**Re: Slim Chickens**  
**8240 Montgomery Blvd. NE**  
**Traffic Circulation Layout**  
Engineer's Stamp 07-5-2022 (G19-D004E)

Re: **SLIM CHICKEN-ALBUQUERQUE  
8240 MONTGOMERY BLVD.NE  
TRAFFIC CIRCULATION LAYOUT  
ENGINEER'S STAMP 05-18-2022 (G19-D004E)**

<div>ENGINEER'S SEAL</div> <div>RONALD R. BOHANNAN NEW MEXICO PROFESSIONAL ENGINEER 7868</div> <div>7-5-22</div> <div>RONALD R. BOHANNAN P.E. #7868</div>	SLIM CHICKEN 8240 MONTGOMERY BLVD NE	DRAWN BY pm
	SITE PLAN FOR BUILDING PERMIT	DATE 7-5-22
	TIERRA WEST, LLC 5571 MIDWAY PARK PL NE ALBUQUERQUE, NEW MEXICO 87109 (505) 858-3100 www.tierrawestllc.com	DRAWING 2021089-SP
		SHEET # SP-1
		JOB # 2021089

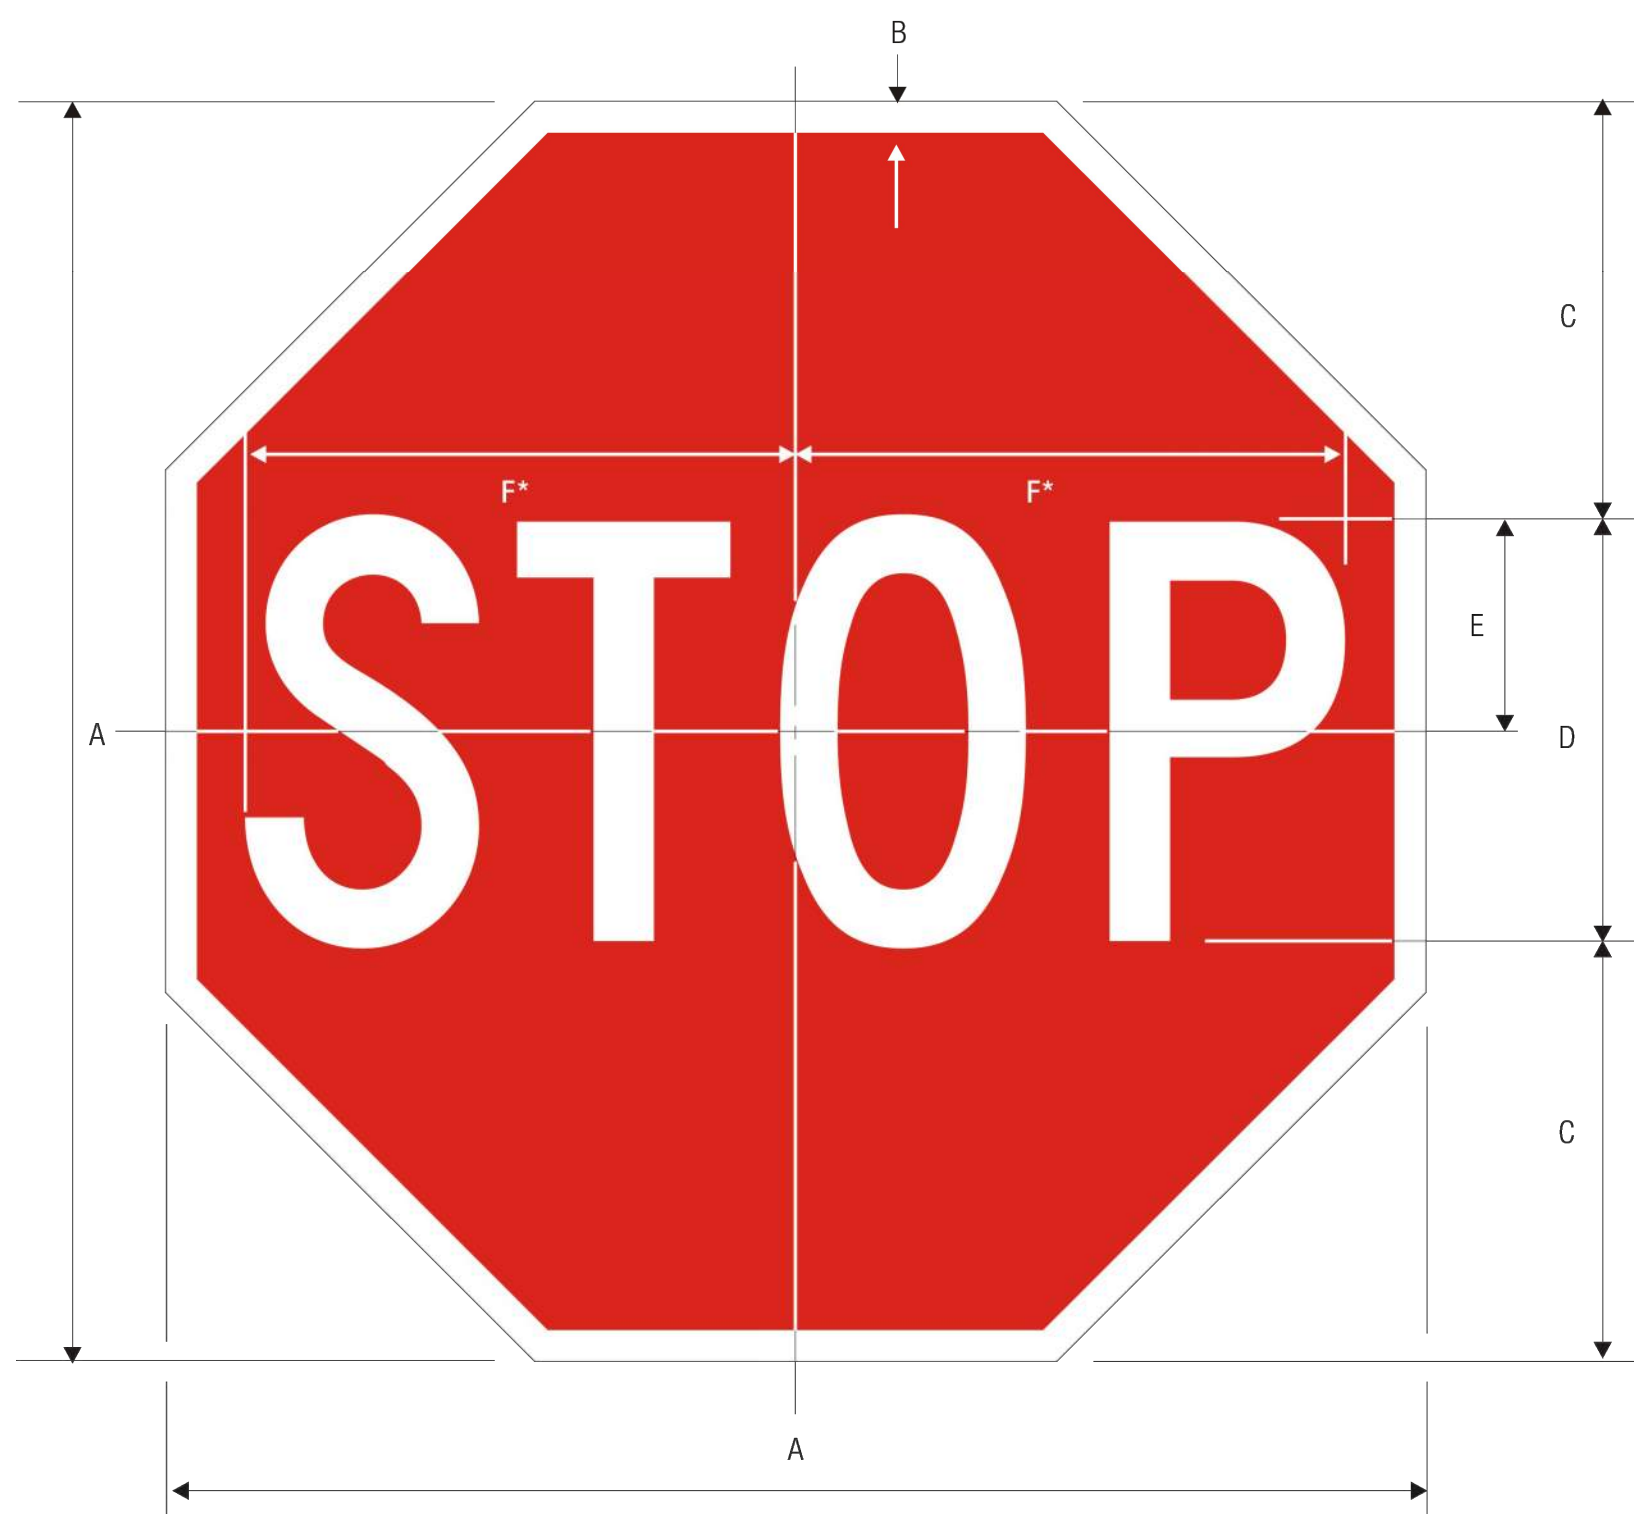
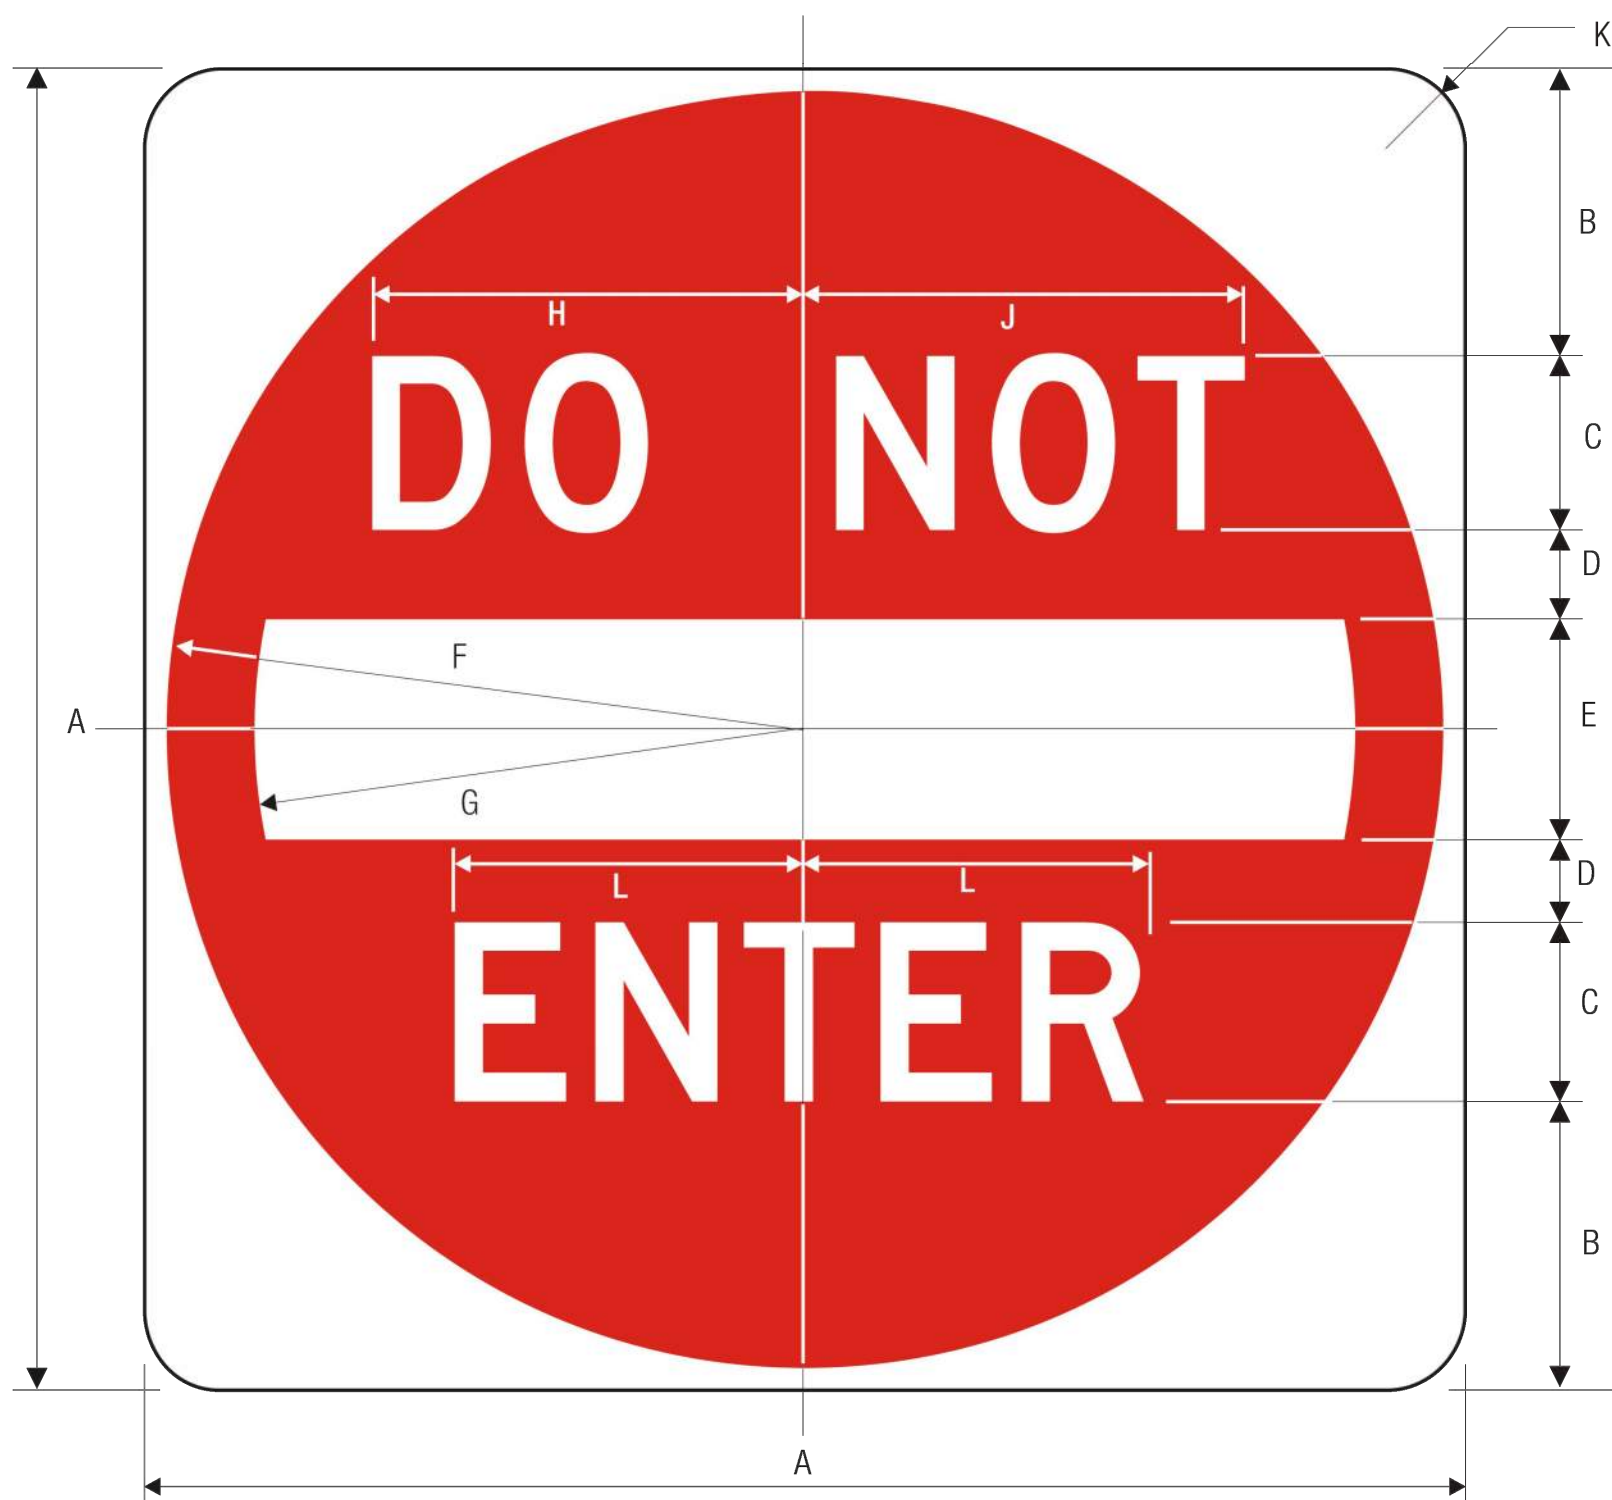
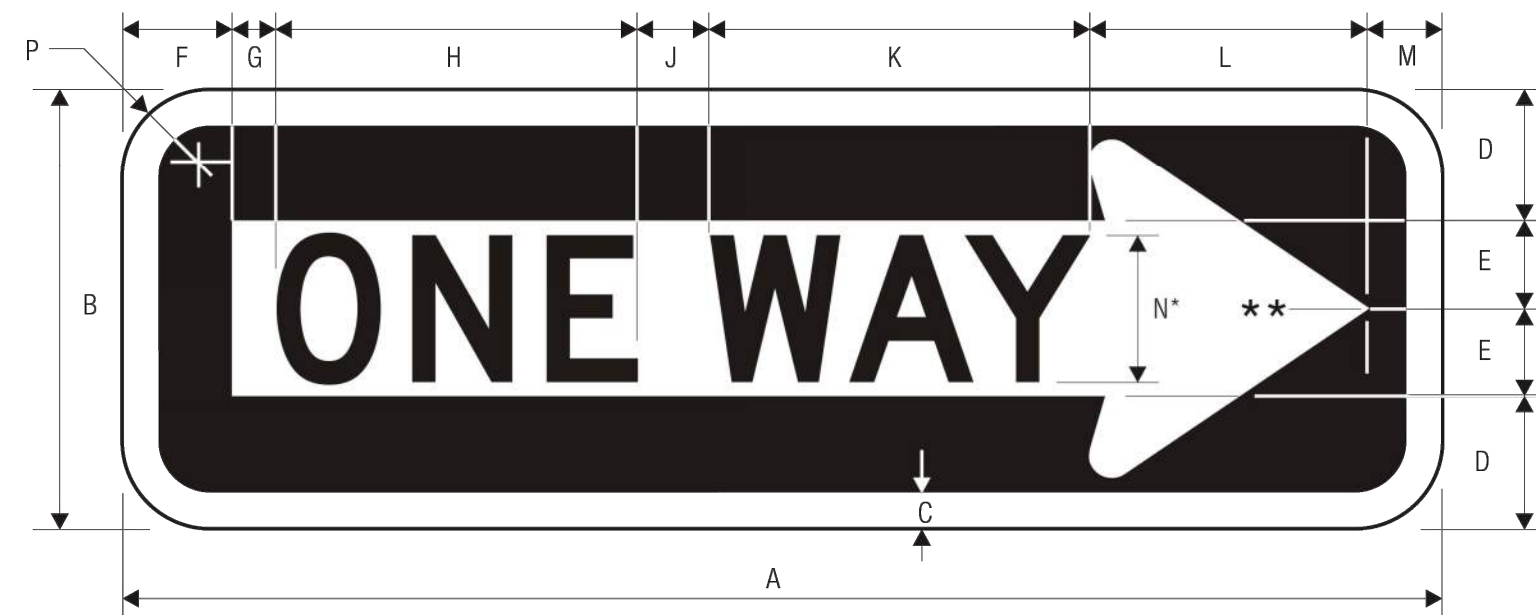
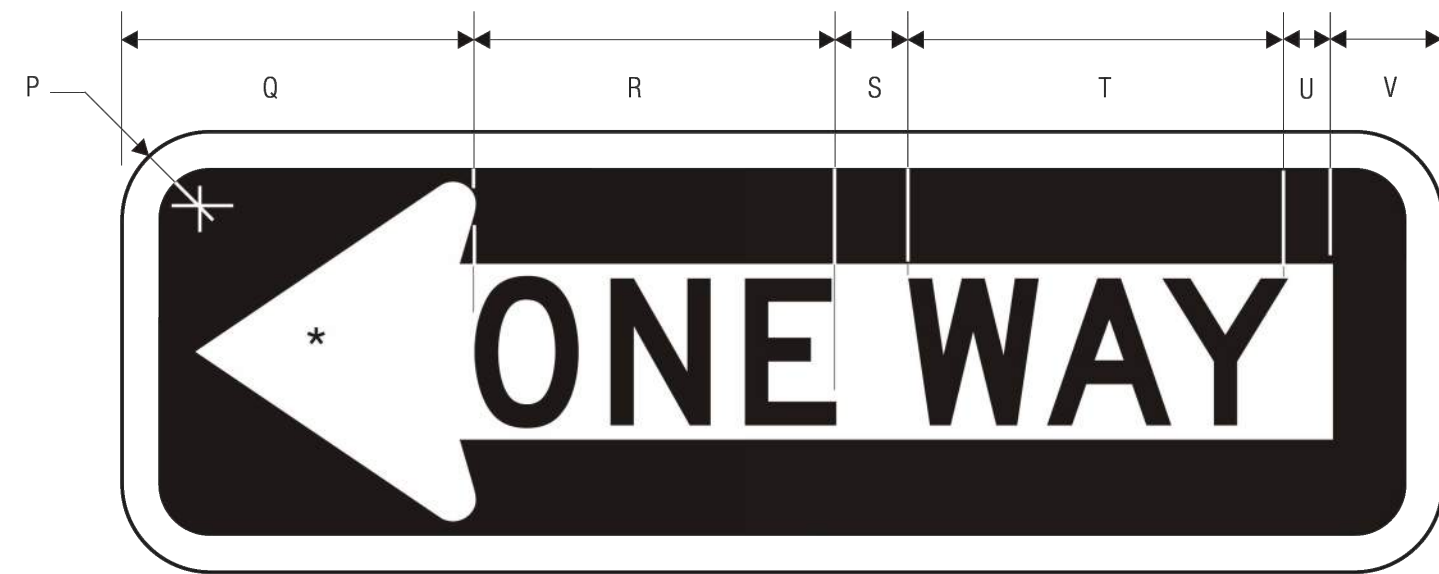
**This was reconfigured as we had discussed on the phone.**
- You will need the following: All one-way drives shall have "One Way" and "Do Not Enter" signage (both sides on exit) and pavement markings. Please show detail and location of posted signs and striping (include Stop Sign and sign face details).

**This information was added to the Site Plan and Detail Sheet.**
- The exit vehicular movement will be dedicated to a left turn movement ONLY. Provide a sign specifying left turn and no right turn out due to the tight radius which cannot accommodate the turn movement
